FINAL ENVIRONMENTAL IMPACT REPORT KELLER AVENUE PROJECT

FINAL ENVIRONMENTAL IMPACT REPORT FOR:
Keller Avenue Development
(Project Title)
California Environmental Quality Act

FINAL ENVIRONMENTAL IMPACT REPORT
for the
Keller Avenue Project

2. RESPONSES TO COMMENTS

KELLER AVENUE PROJECT WORKSHEET
AM PEAK HOUR EXISTING & 1990 MOVEMENTS

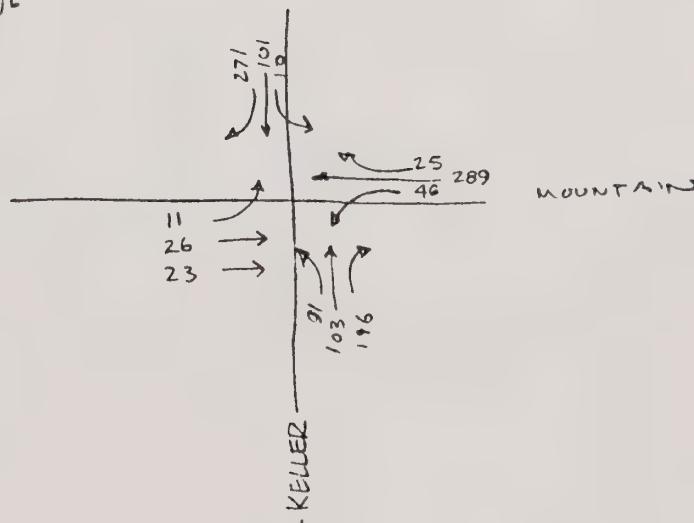
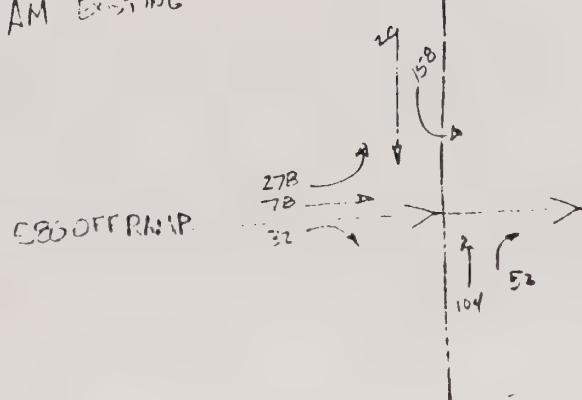
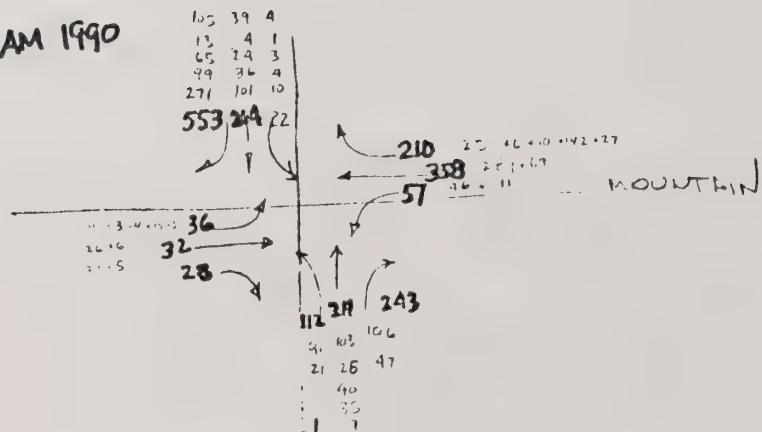
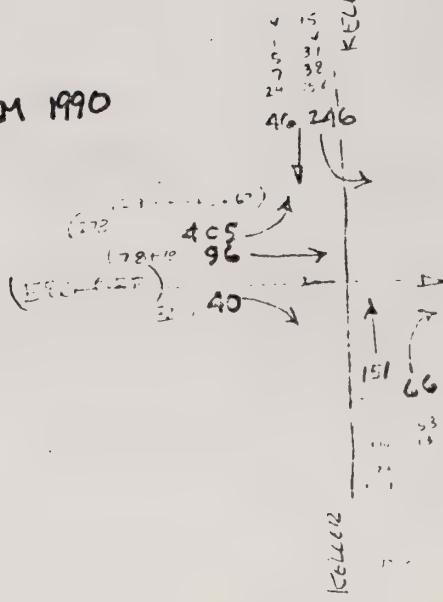
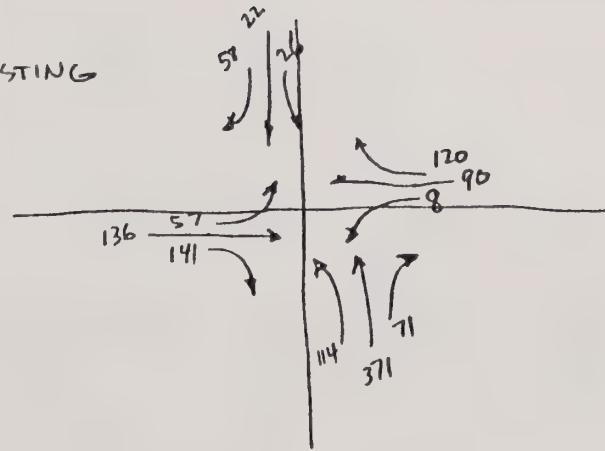
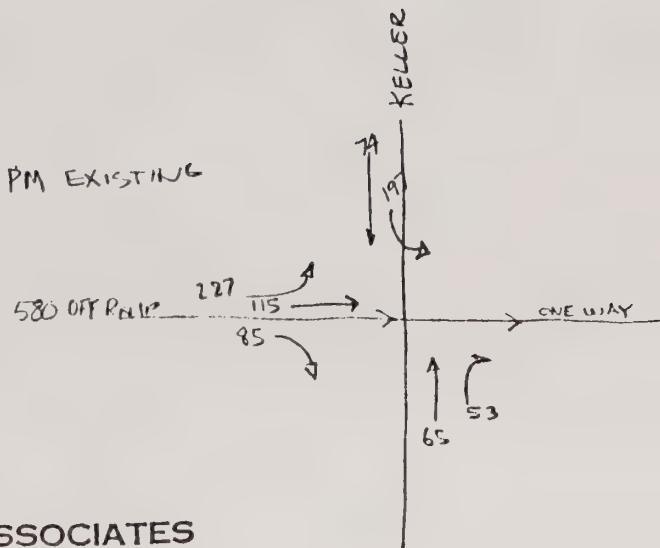
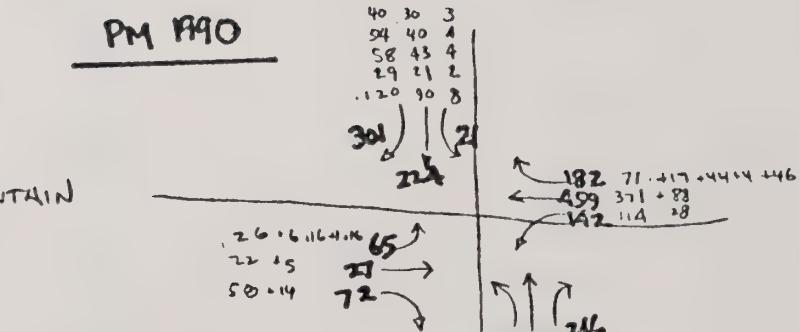
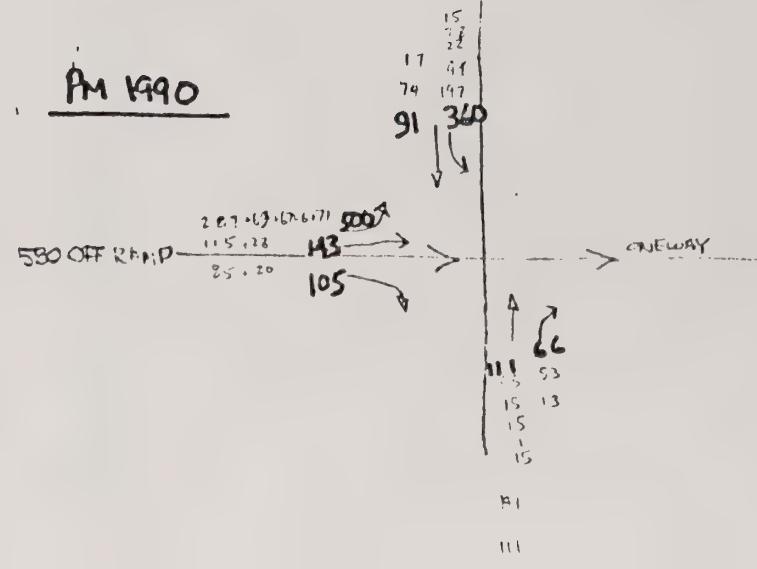
Comment: 7. For better corroboration of the evaluation of future intersection conditions (page 53, lines 19-23), four turning movement diagrams for the 1990 condition are needed. The basis data should be readily available to the traffic consultants.

Resonse: 7. The work sheets showing existing and 1990 AM and PM turning movements at Keller Avenue/I-580 southbound off-ramp and Keller Avenue/Mountain Boulevard are attached.

KELLER AVENUE AT MOUNTAIN BOULEVARD

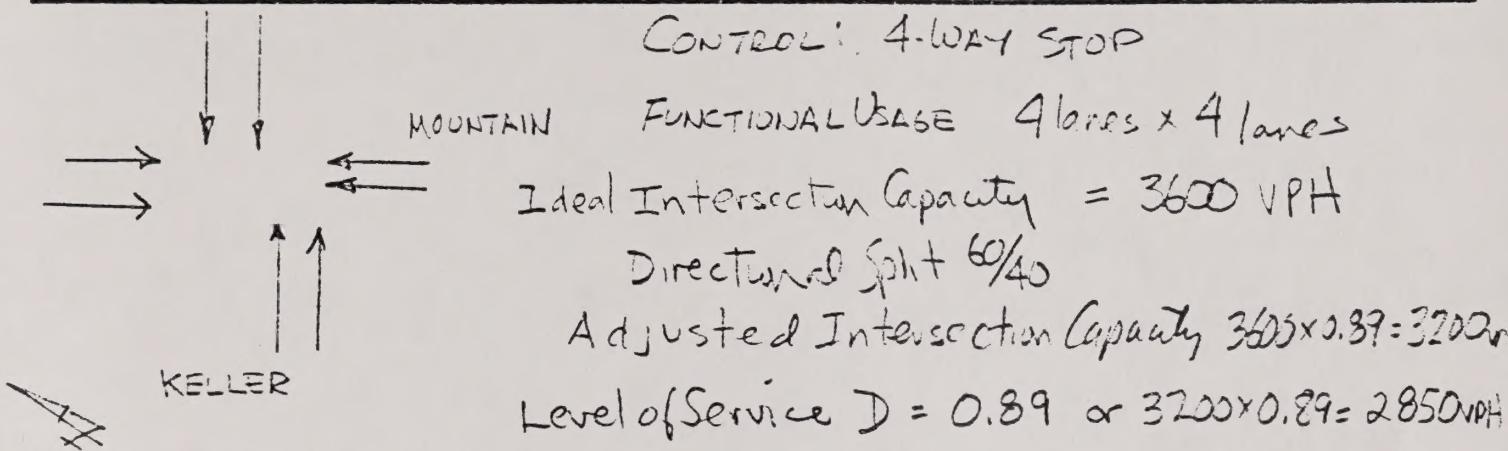
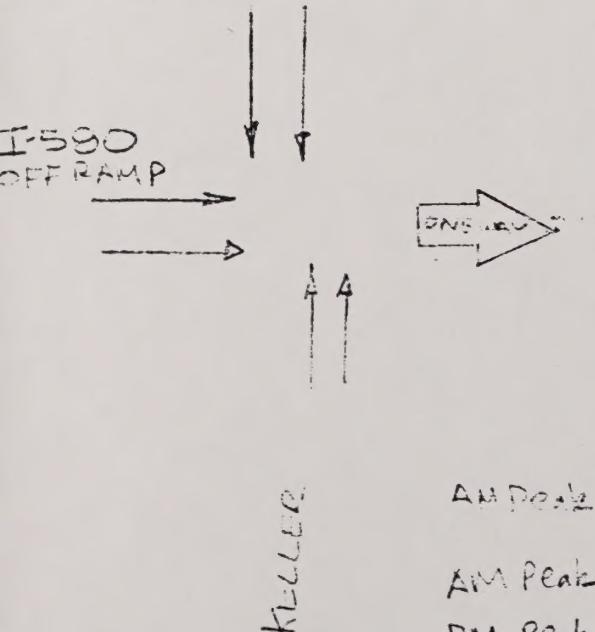
Comment: 2. Project generated traffic will probably have a significant impact on the AM and PM peak hour operation of the Keller Avenue/I-580 interchange. We would like to see the capacity analysis for both intersections at the I-580 ramps/Keller Avenue interchange.

Response: 2. Capacity calculation work sheets are attached and the capacity utilization for the Mountain Boulevard/Keller Avenue intersection was described in the Intersection Analysis section of the report.

AM Peak Existing Traffic Entering = $732/3200 = 0.23$ (LOS A)AM Peak 1990 Traffic Entering = $1050/3200 = 0.32$ (LOS A)PM Peak Existing Entering = $1192/3200 = 0.37$ (LOS A)PM Peak 1990 Entering = $2066/3200 = 0.65$ (LOS B)KELLER AVENUE AT SOUTHBOUND I-580 OFF RAMP

Adjusted Intersection Capacity $1900 \times 0.95 = 1800$ Level of Service D = 0.89 or $1800 \times 0.89 = 1620$ AM Peak Existing Entering $732/1800 = 0.41$ (LOS A)AM Peak 1990 Entering $1050/1800 = 0.58$ (LOS A)PM Peak Existing Entering $376/1800 \approx 0.49$ (LOS A)PM Peak 1990 Entering $1376/1800 = 0.76$ (LOS C)
